From: [REDACTED]
Sent: 10 February 2026 10:54
To: Anna Tidey
Subject: RE: DM/25/3101 & DM/25/3102 - Discharge of conditions application/ Variation of condition application - Blackbirds, Bramble Hill, Balcombe

'Variation of condition No: 2 relating to DM/25/0873 to allow for minor changes to the overall design which include rear extension parapet roof additional of roof glazing in the side extension and enlarged porch extension with open gable.'

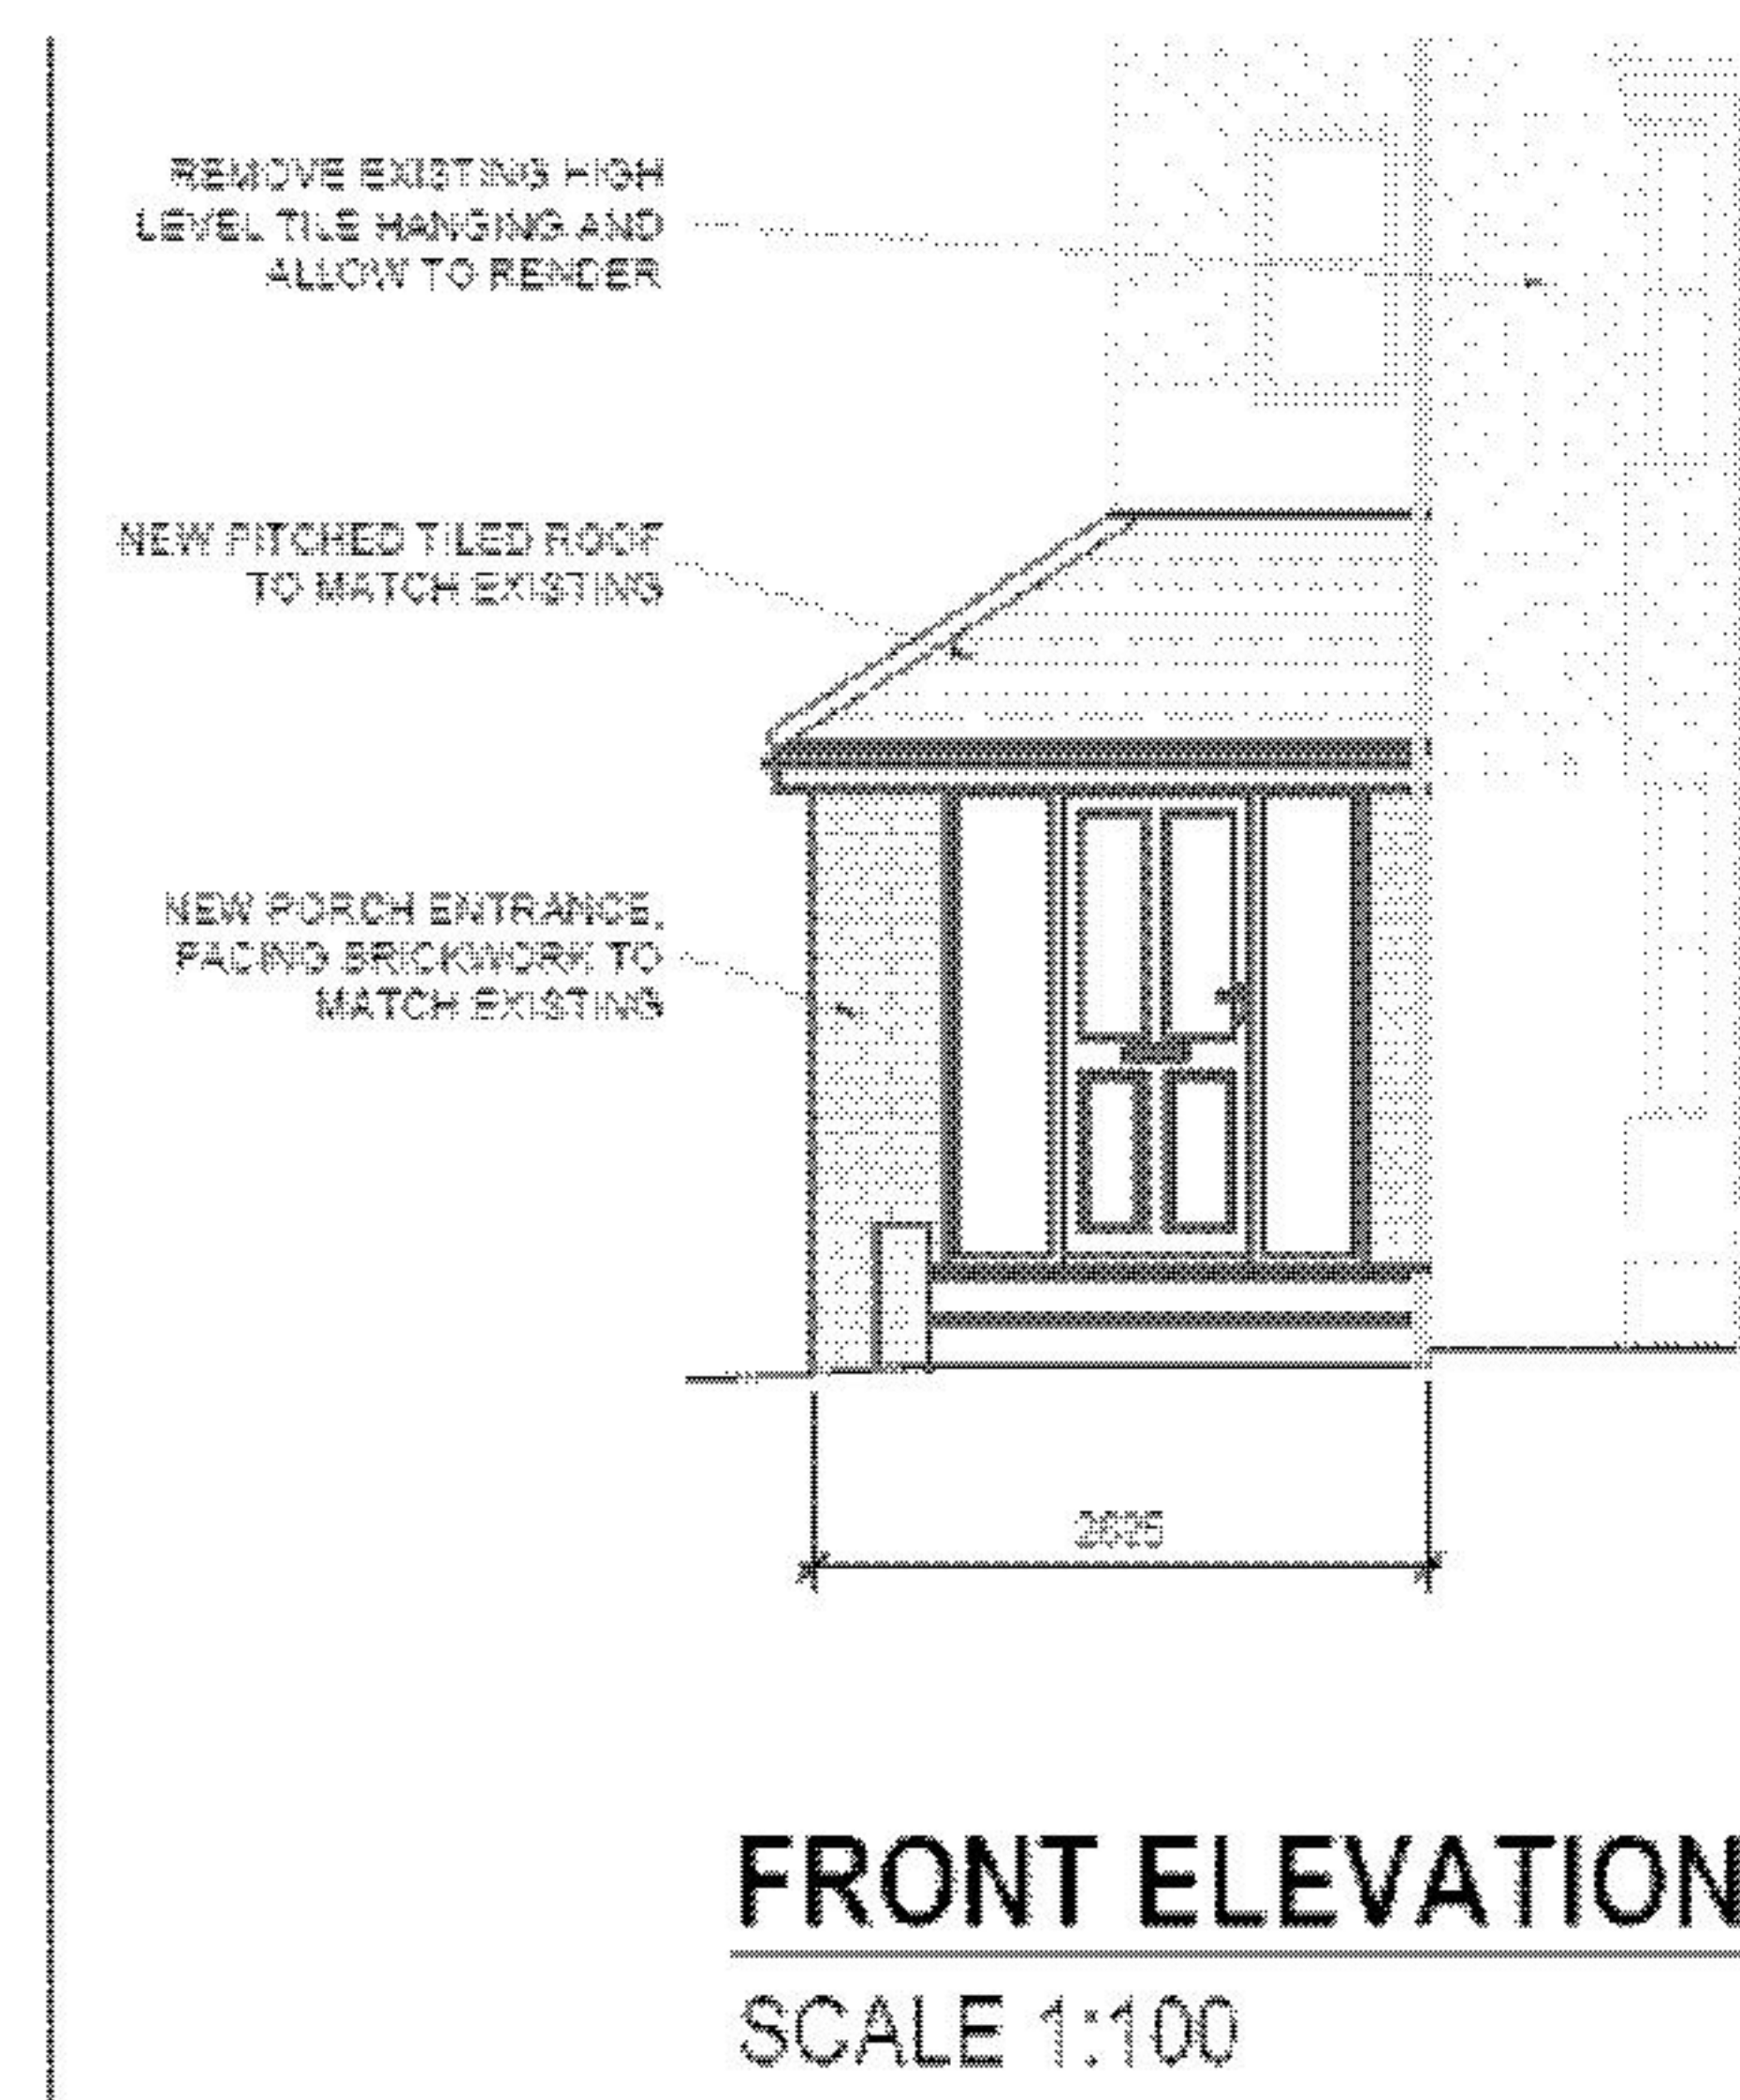
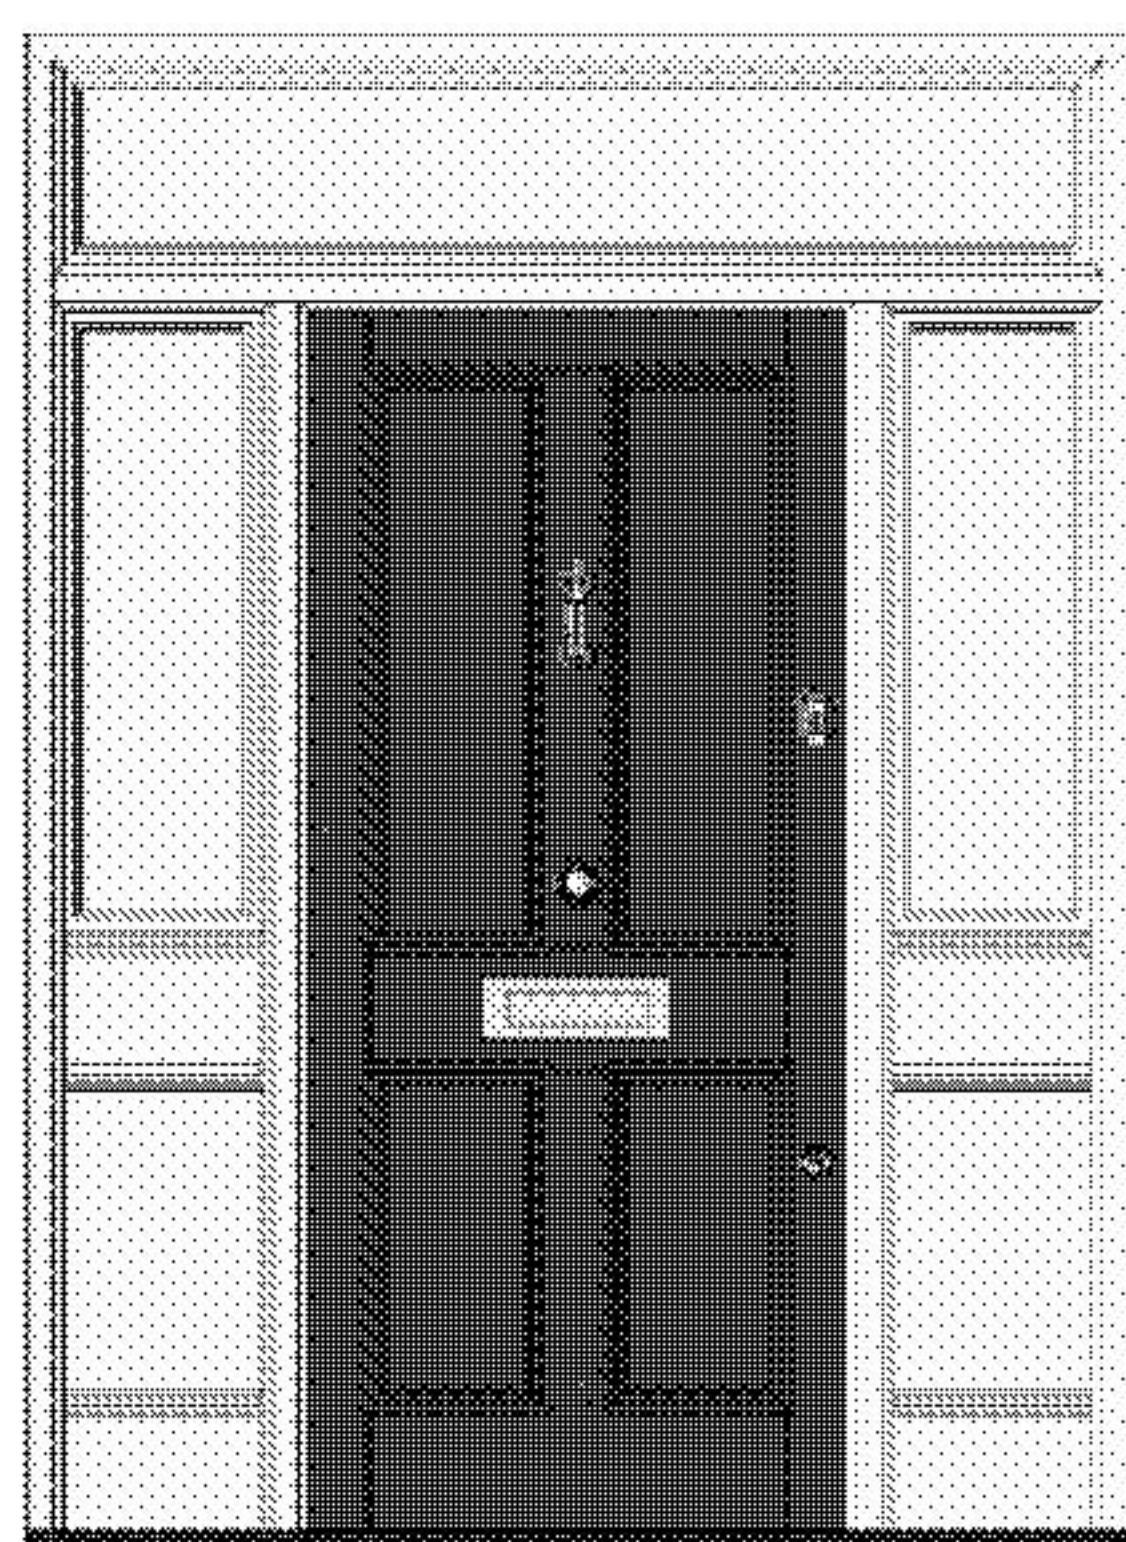
Thank you for your email regarding **DM/25/3102 - Discharge of conditions application**, the content of which I will review with Emily Wade. I note that the submitted front door detail does not correspond to the door design/glazing layout as shown on Proposed Floor and Elevations Plan No1252-02 Rev 05, as approved under DM/25/0873, see copied images below:

The submission of material details for discharge should accord with the Approved Plans showing the design which is to be implemented. A decision will not be made on this application as I have made the application INVALID pending further information on this point.

The front doorway is to be amended to that shown on Proposed Plans & Elevations Drawing No 02, Rev 8, as submitted under DM/25/3101. Please advise the best way forward regarding the validation / approval of each application.

You may wish to await approval of amended plans ahead of applying for the discharge of the materials condition. Please can you confirm if the front doorway is to be amended to that shown on Proposed Plans & Elevations Drawing No 02, Rev 8, as submitted under DM/25/3101?
